RECEIPT DATE: 1/9/26 **ONSITE SEWAGE DISPOSAL SYSTEM** P 590315

PROPERTY ADDRESS: 1734 Brickell Way

RECEIPT DATE: 1/9/26 **ONSITE SEWAGE DISPOSAL SYSTEM** P 590315--A
 INSTALLATION
 APPROVAL DATE: 2/13/26 **PERMIT** A _____
SEWER HOUSE CONNECTION

PLAN TO ACCOMPANY PLUMBING CONNECTION PERMIT/SEPTIC PERMIT

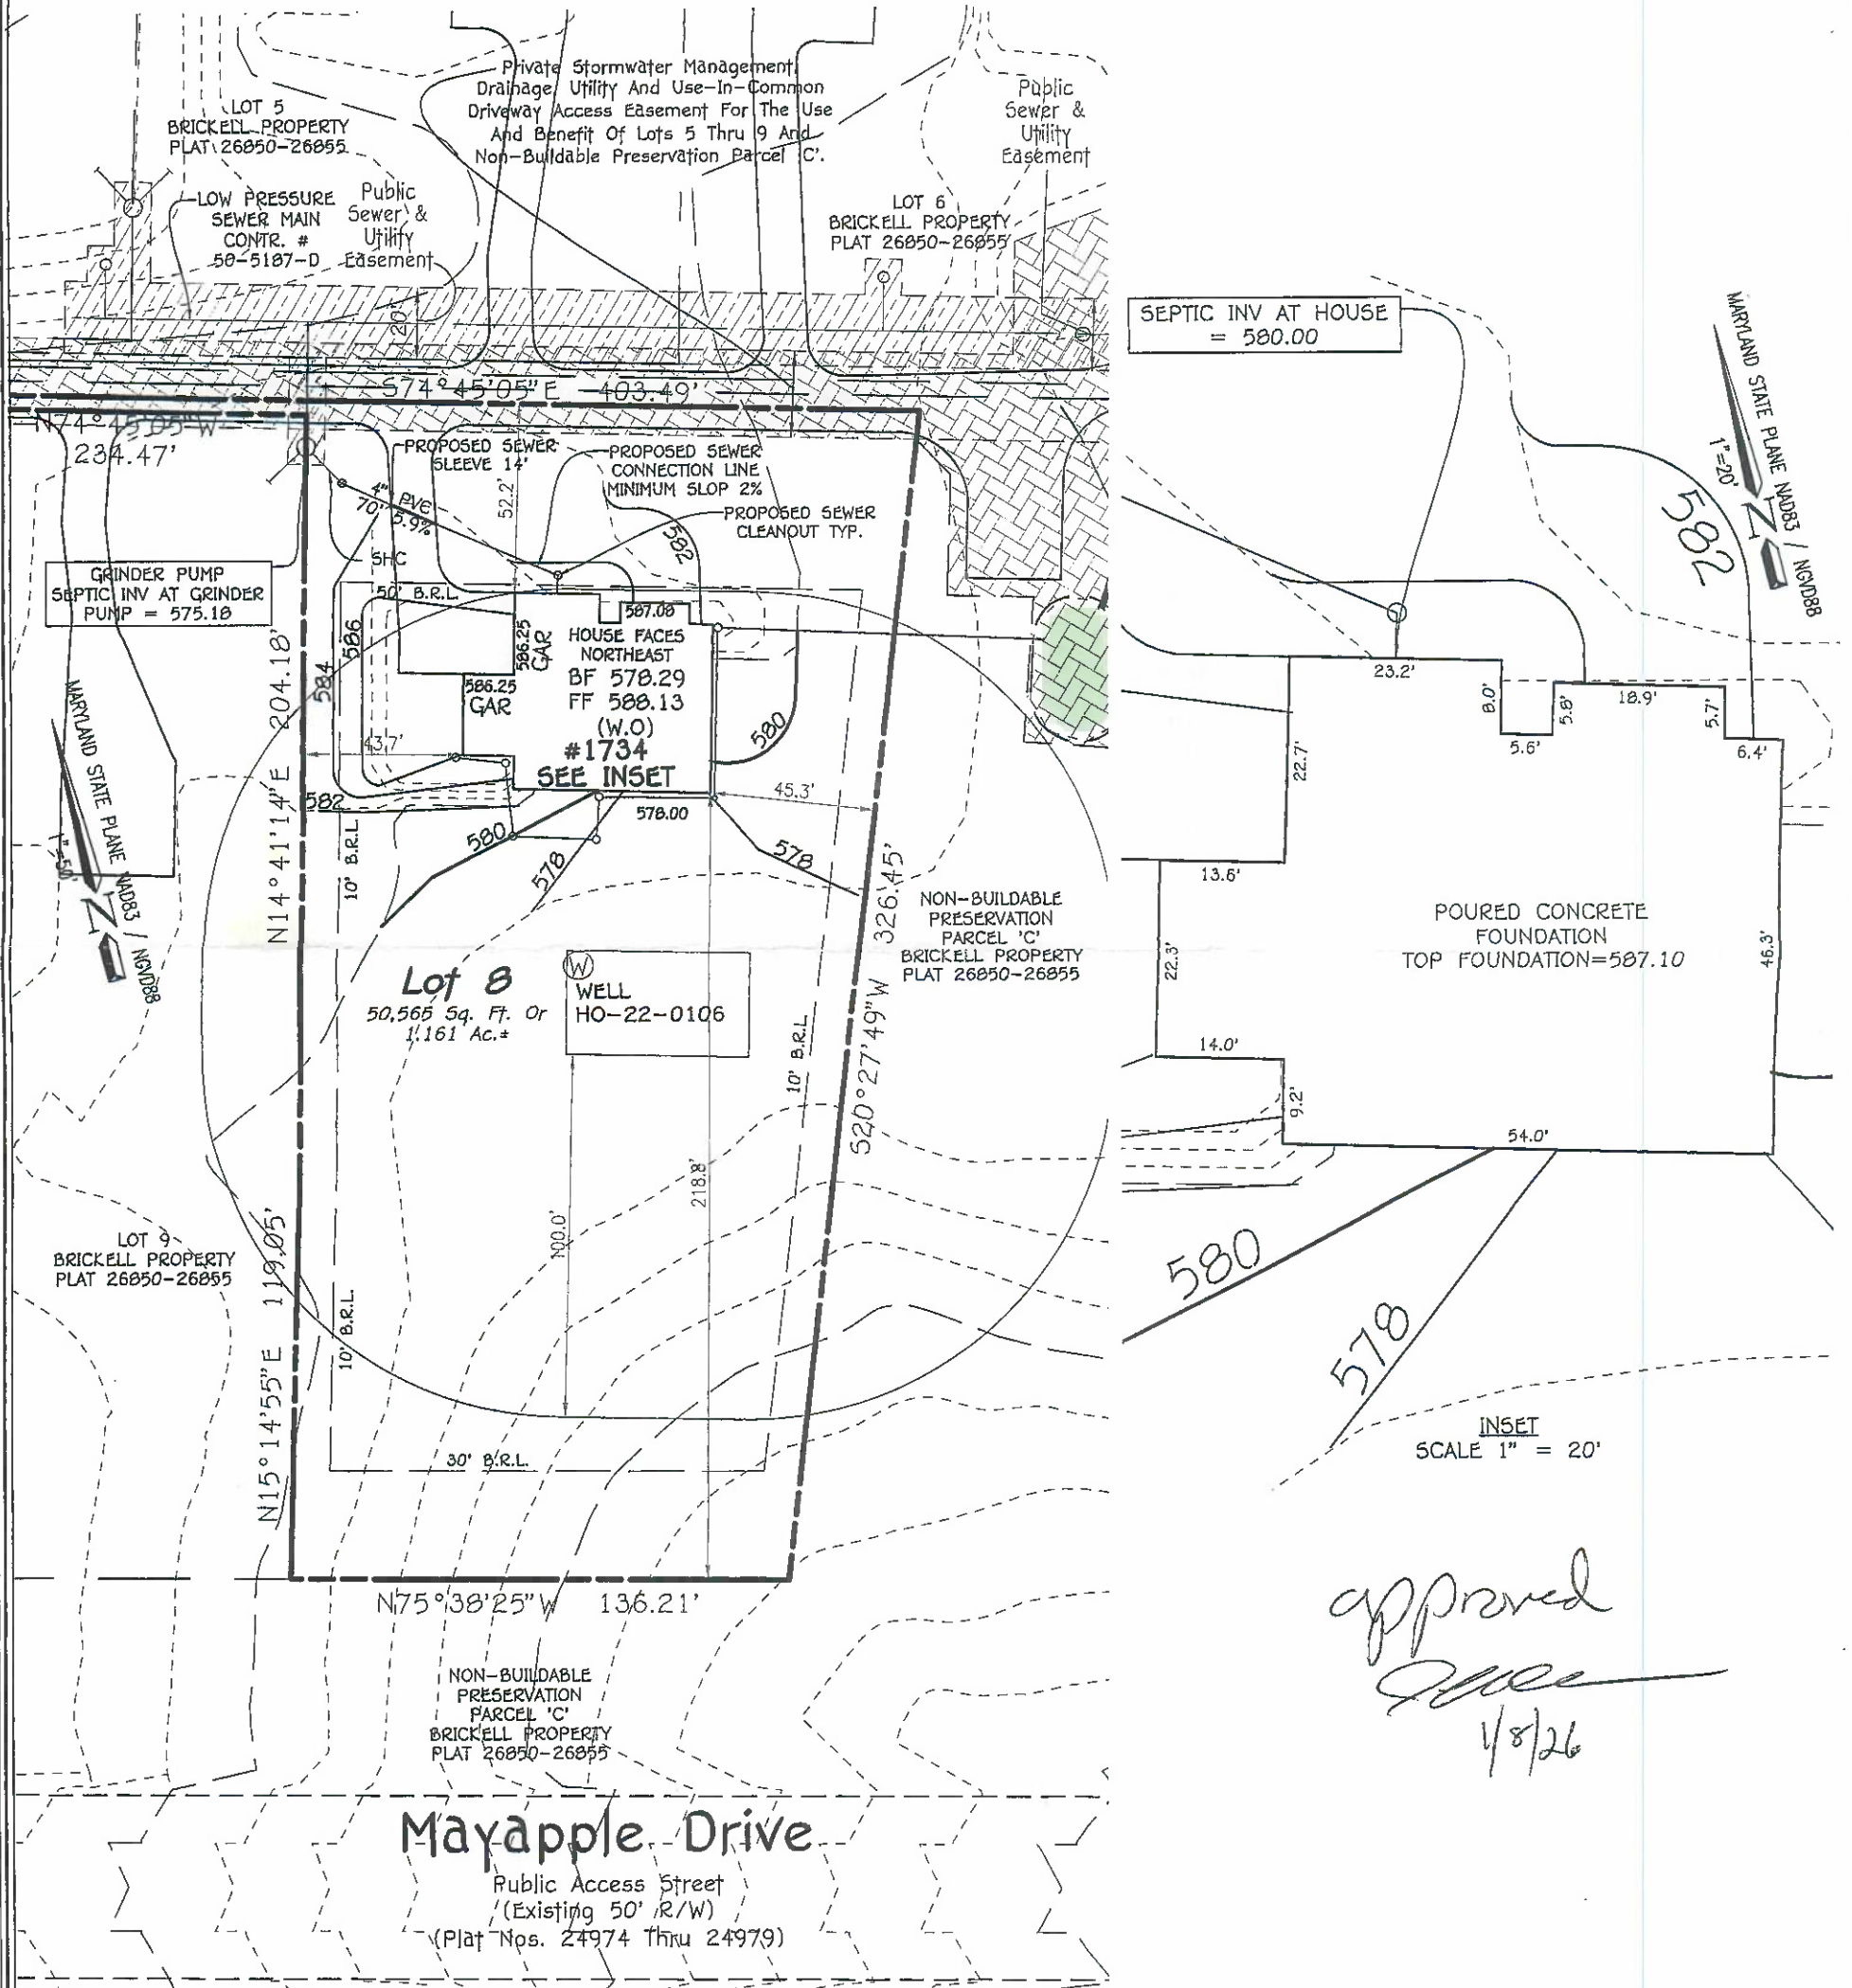
* NOTE: AS of 2/12/26 - the location of the SHC has changed from the location on the approved septic connection permit dated 1/8/26

INSTALLATION NOTES:
 1/29/2026 - Installer onsite for inspection. 50' of sewer line sleeved under driveway. 17' of line sleeved crossing water line. 2% fall achieved. Reinspect for sleeved sewer crossing water line & connection to house foundation. SP 2/2/26 - inspection completed w/ installer. sewer line sleeved w/ added seal using Fernox-see-nic in file. water line was severed during this installation. contractor stated that the well (water) line would be repaired by a different company and called in for inspection. reinspection required for SHC. SP 2/13/26. Sewer house connection made. line is sleeved above the well line and is sealed with rubber Fernox. Water line repaired and sleeved SP

* House Connection made at a different location.
See As-built for accurate sewer house connection drawing. **(16)**
